**From:** Paul Kallan  
**Sent:** Thursday, July 17, 2008 1:07 PM  
**To:** Seshagiri Tammara  
**Subject:** FW: ABR-AE-08000052  
**Attachments:** ER RAI Response LTR 2 (ABR-AE-08000052).pdf

**From:** Kiesling, Russell W [mailto:rwkiesling@STPEGS.COM]  
**Sent:** Wednesday, July 16, 2008 11:25 AM  
**To:** Adrian Muniz; Belkys Sosa; George Wunder; Paul Kallan; Loren Plisco; Raj Anand; Rocky Foster; Tekia Govan; Tom Tai  
**Subject:** ABR-AE-08000052

South Texas Project  
Units 3 and 4  
Docket Nos. 52-012 and 52-013  
Response to Requests for Additional Information

**Figure 1-** Comparison of TWDB and USGS reported total groundwater withdrawals for Matagorda County from 1980 through 2005.

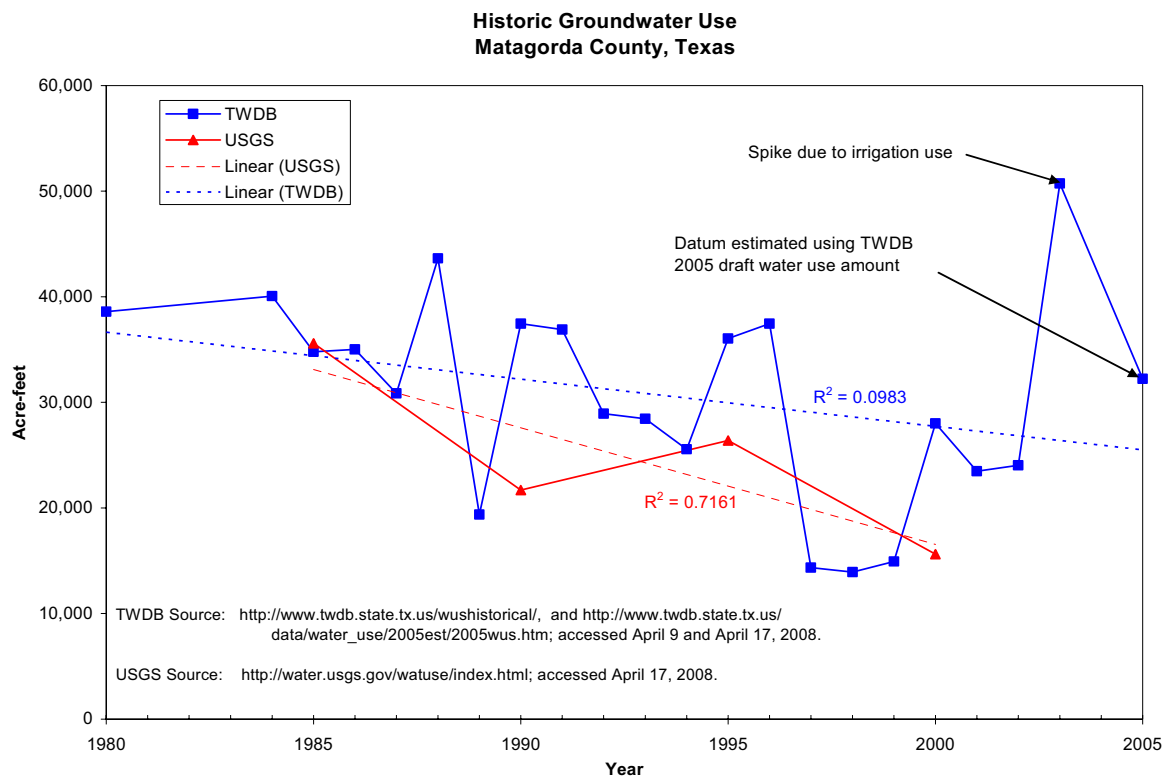
Provide a projection of future groundwater use in Section 2.3.2.2, and provide a breakdown of water demand, described in Table 2.3.2-6, between that to be provided by surface water and groundwater resources.

(1) Provide a summary discussion of the underlying rationale for the substantial decline in groundwater consumption in Matagorda County (~50%) by 2030 forecasted by the State of Texas in 1985 (e.g., movement from groundwater to surface water sources because of salt or brackish water intrusion, an observed and marked decline in groundwater quality). Has salt or brackish water intrusion been observed, evaluated, or forecasted for the Chicot aquifer? Since the 1985 forecast, how has groundwater resource utilization changed? Has the forecast become reality? Based on the NRC's initial independent evaluation, in discussions with the Coastal Plain Groundwater Conservation District (CPGWCD) during the ER Site Audit in February 2008, the 1985 forecast does not appear to have materialized and that portraying groundwater usage in Matagorda County in this light may not be current despite the availability of a State authored reference. Provide a discussion to reconcile these views.

(2) Provide a projection of future groundwater use in Section 2.3.2.2 that could affect or be affected by the construction or operation of the proposed project. The current discussion is limited to current or present-day usage. Table 2.3.2-6 provides the water demand for the Lower Colorado River Region; however, it appears to represent the combined surface water and groundwater demand. If the table reflects the combined demand, then provide a breakdown of the water demand described in Table 2.3.2-6 between surface water and groundwater resources.

Further complicating the situation, the TWDB-approved water demand projections are not presented with separate surface water and groundwater figures as some water regions merge the two together to manage their water resources. Using Region K estimates, CPGCD predicts combined surface and groundwater demand estimates for Matagorda County will exceed projected supplies in the future. Water conservation strategies and desalination of sea water and deeper brackish groundwater have been proposed to help meet the projected demand.

Like many aspects of Texas water regulations, water use projections can be confusing, mostly due to the conflicting information and methodologies used by the different agencies involved and the lack of “separation” of surface and groundwater use in these projections. To help remedy this, historic groundwater use estimates were obtained from TWDB and USGS Internet websites to obtain the percentage of groundwater use in the county by user groups (e.g., irrigation, industry, municipal, mining, livestock, and power generation). As shown in Figure 1, the USGS data (USGS *Estimated Use of Water in the United States* Internet Weblink) exhibit an overall downward trend from 1985 at 35,589 AF/Y to 2000 at 15,614 AF/Y with a fair reliability of correlation of  $R^2 = 0.72$ . The TWDB data (TWDB *County Water Demand Projections* Internet Weblink) exhibit more variability, largely due to irrigation, and as a result the TWDB data have no correlation to the generated trend line. This may be in part attributable to the USGS database being collected every five years and the TWDB data being collected approximately annually. Neither database has 2005 or later data available as of May 13, 2008.

Because separate groundwater demand projections for Matagorda County are not available, groundwater utilization for Matagorda County was estimated in the FSAR using projected water use from the Lower Colorado Regional Water Planning Group (LCRWPG) Water Plan and historic uses from the TWDB. To provide further insight to how the groundwater utilization may have changed since the forecast presented by TDWR in 1985, the data collected by the USGS regarding historic groundwater use in Matagorda County were also used to provide a “separation” of groundwater from the TWDB-approved water demand projection data.

Based on the individual water use group projections detailed in FSAR Section 2.4S.12.2.1, summarized in Table 2.4S.12-6 and illustrated in Figure 2.4S.12-14, a groundwater use projection for Matagorda County for 2060 is estimated to be about 42,000 acre-feet. Using the USGS historic groundwater use data, a similar projection is estimated to be about 32,500 acre-feet. The contrast illustrates the problem of dealing with the combined projected water uses provided by the TWDB. However, both of these estimates are below the estimated groundwater availability amount of 49,221 acre-feet for Matagorda County (Turner Collie & Braden, Inc., 2004).

Figure 2.5-23. Palacios Revenues by Source, 2007 Total Revenues: \$1.8 Million

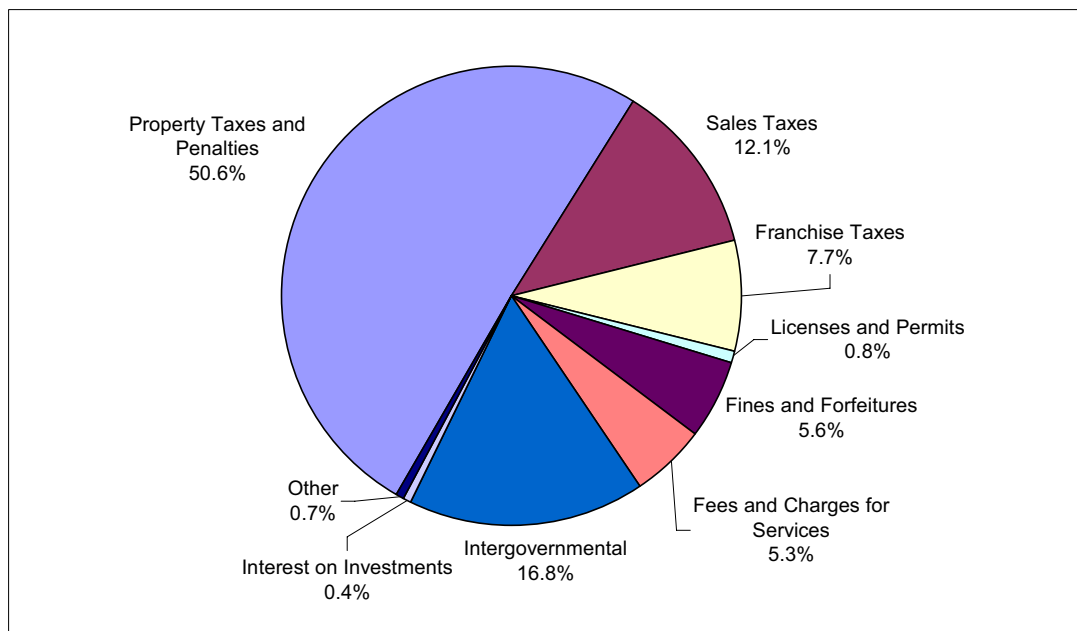
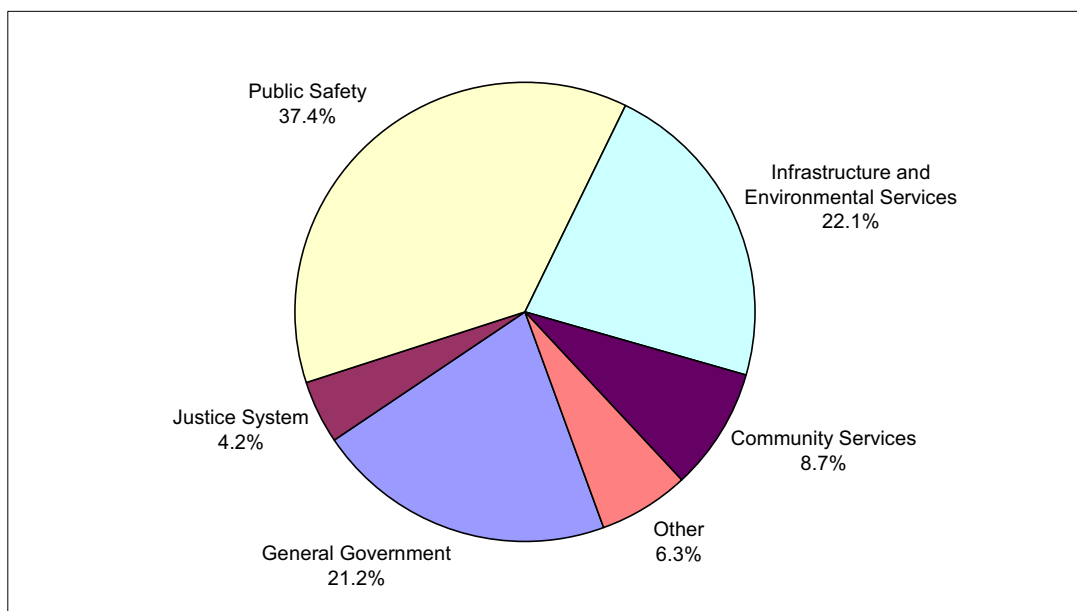
Provide revenue and expenditure data for the City of Palacios.

Data are available on revenues and expenditures in the City of Palacios. The paragraph, tables, and figures shown below will be included in the revised draft of ER 2.5.2.

Unlike Bay City, the City of Palacios receives approximately half of its revenues from property taxes, accounting for 50.6% of 2007's total revenues of \$1.8 million. The Palacios proposed budget for 2008 showed a 31.4% increase in property tax revenues over the adopted budget for 2007. In Palacios, whose population as of the 2000 Census was roughly one-fourth the size of Bay City's (Reference 2.5-3), sales taxes accounted for only 12.1% of total revenues, reflecting the much smaller retail sector. Table 2.5-43 and Figure 2.5-23 illustrate Palacios revenues by source. Total budgeted expenditures in Palacios for 2007 were nearly \$2.2 million, with 37.4% spent on public safety, 21.2% on general government, and 22.1% on Infrastructure and Environmental Services. Expenditures by category are summarized in Table 2.5-44 and shown in Figure 2.5-24.
